LIFT STATION #1 REPLACEMENT

***SITE DEVELOPMENT PLAN
DRAINAGE LETTER***

**RE: Woodmen Hills Metropolitan District
Lift Station #1 Replacement
Administrative Plot Plan – Drainage Letter
Address: TBD (Current Site Address: 12048 Falcon Highway, Peyton, CO 80831)**

WOODMEN HILLS METROPOLITAN DISTRICT
LIFT STATION #1 REPLACEMENT
DRAINAGE EXHIBIT

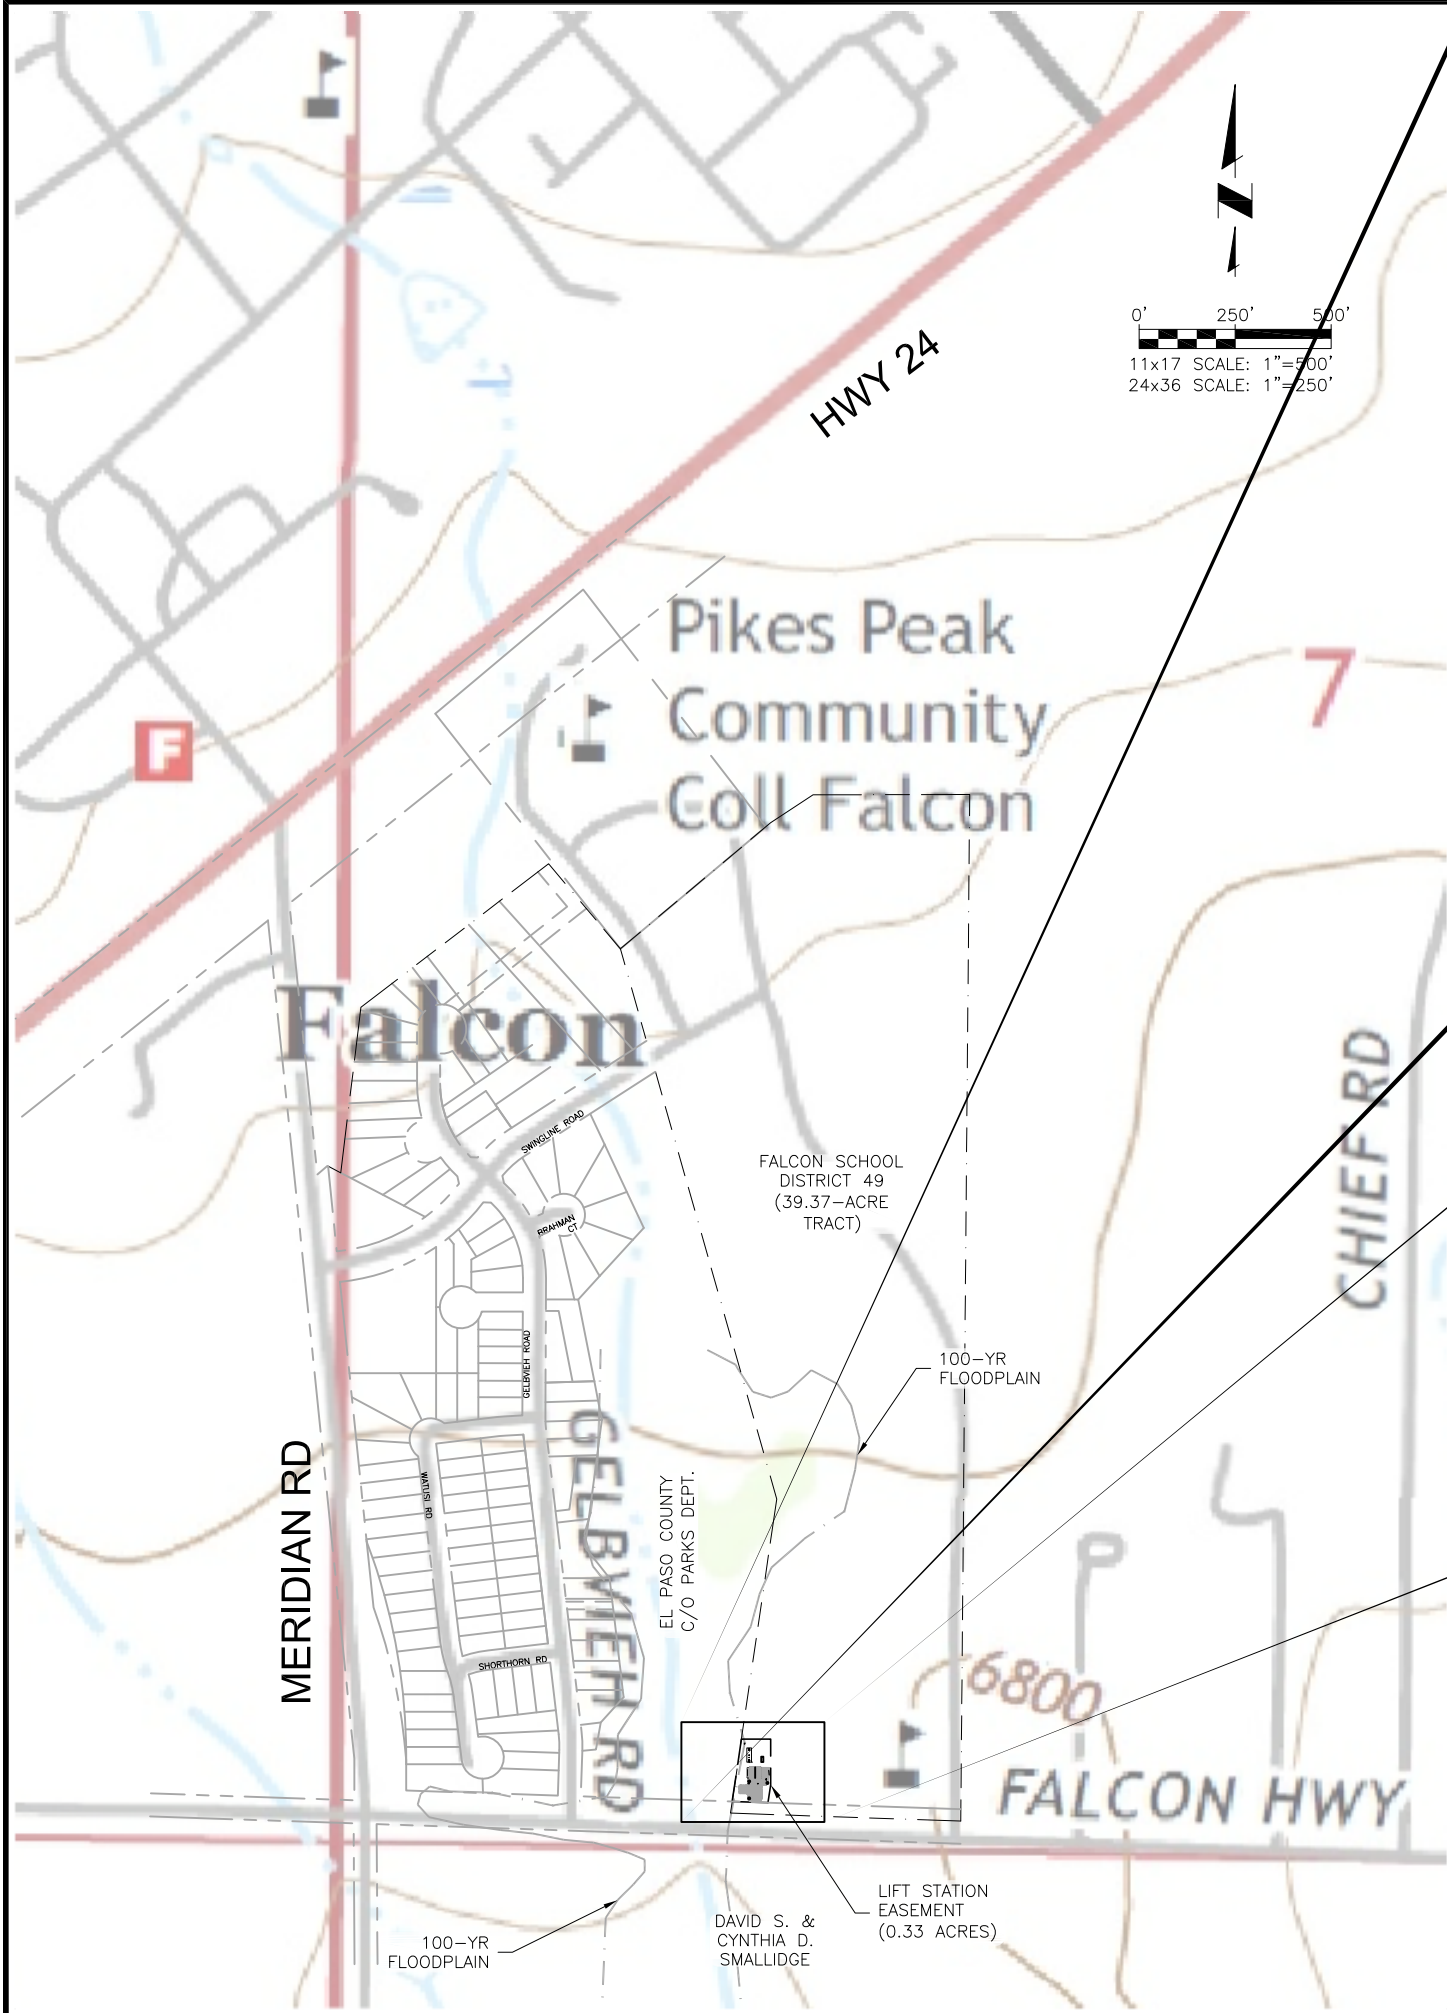
Move this sheet after the coversheet.

Move this sheet after the coversheet.
